# Groundwater Transfer Review Summary Form

Transfer/PA # T- 13914

Application: T-13914

Proposed Changes:  POA  APOA  SW→GW  RA  
 USE  POU  OTHER

## Stratigraphic Cross Section

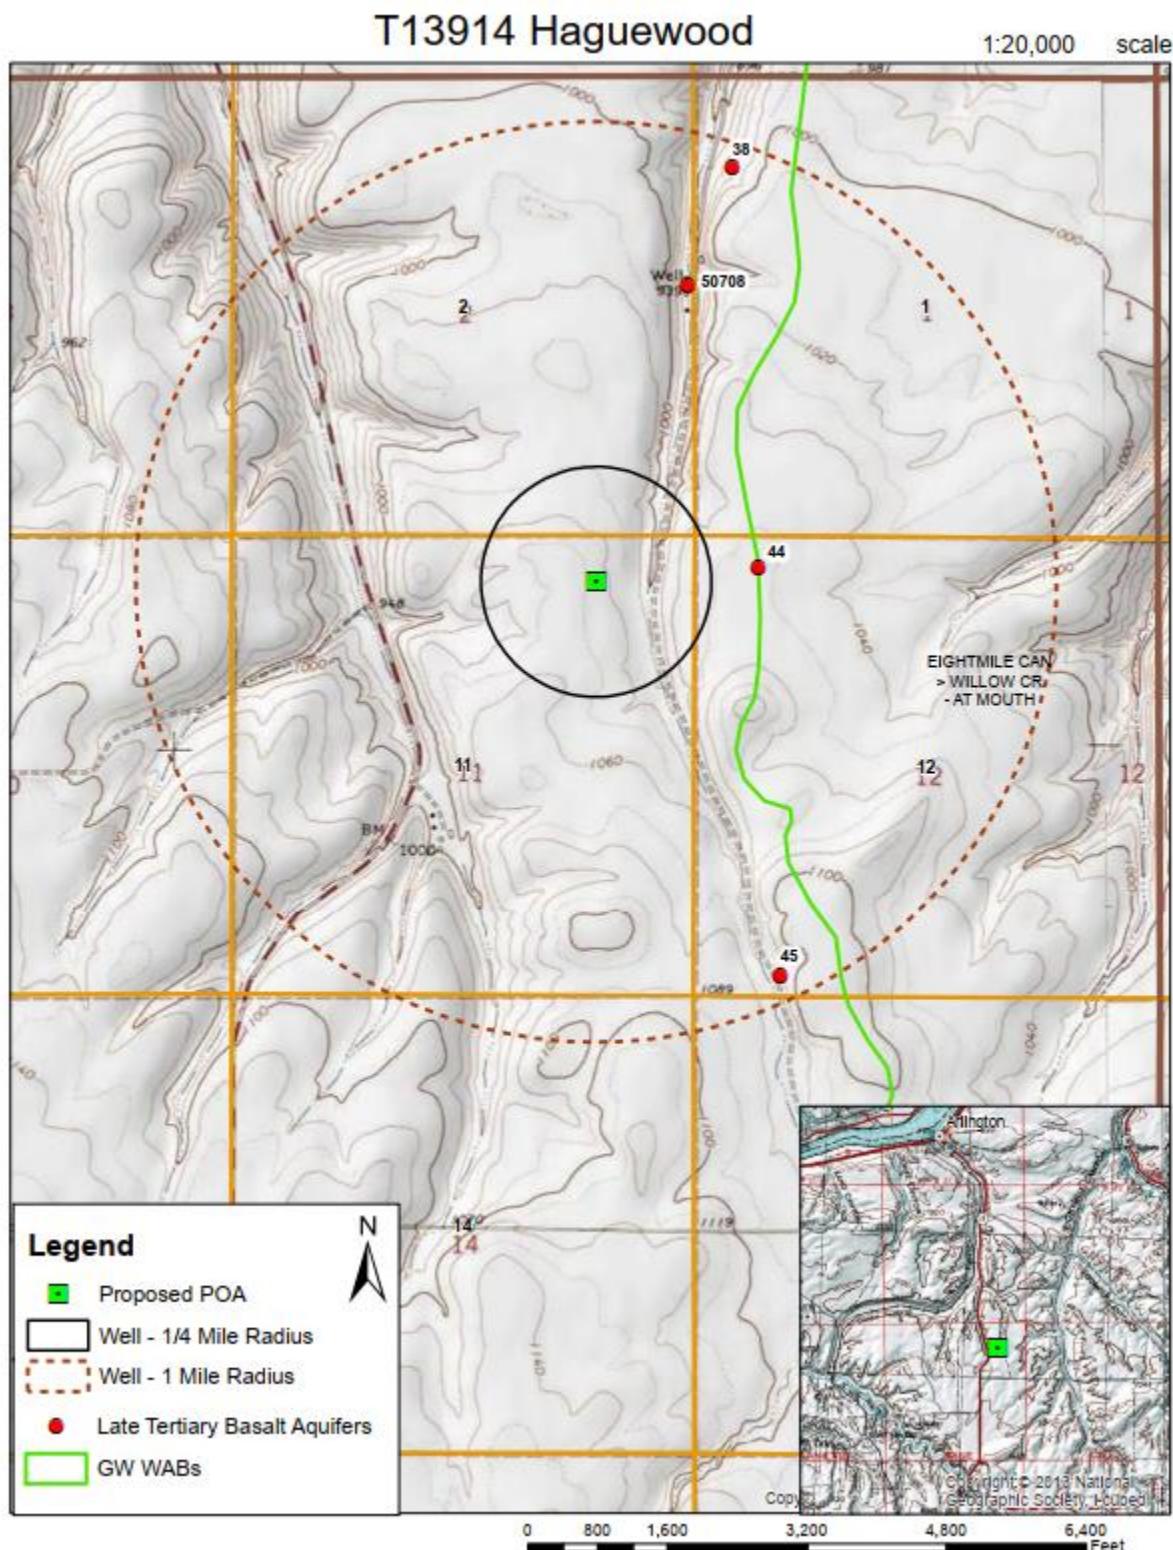
In many areas where CRBG wells are present, water levels in individual interflow zones are distinct and isolated. This does not appear to be true locally. With few exceptions, water levels in local wells are independent of well depth. Evidence of this is shown on geologic cross-section A-A' (cross-section is Figure 8, location map is Figure 7). This cross-section shows geologic units penetrated by each well and the most recent static water level elevation. Water levels are from spring 2017 or 2018 unless noted on the cross-section. As mentioned previously, water level elevations decrease consistently along the cross-section from south to north and are a representation of the regional groundwater flow gradient. The fact that water level elevations are consistent over a broad area and show little variation with well depth or geologic units penetrated indicates some interconnection between water-bearing zones in these different units and suggests these water-bearing zones behave as a single aquifer locally.
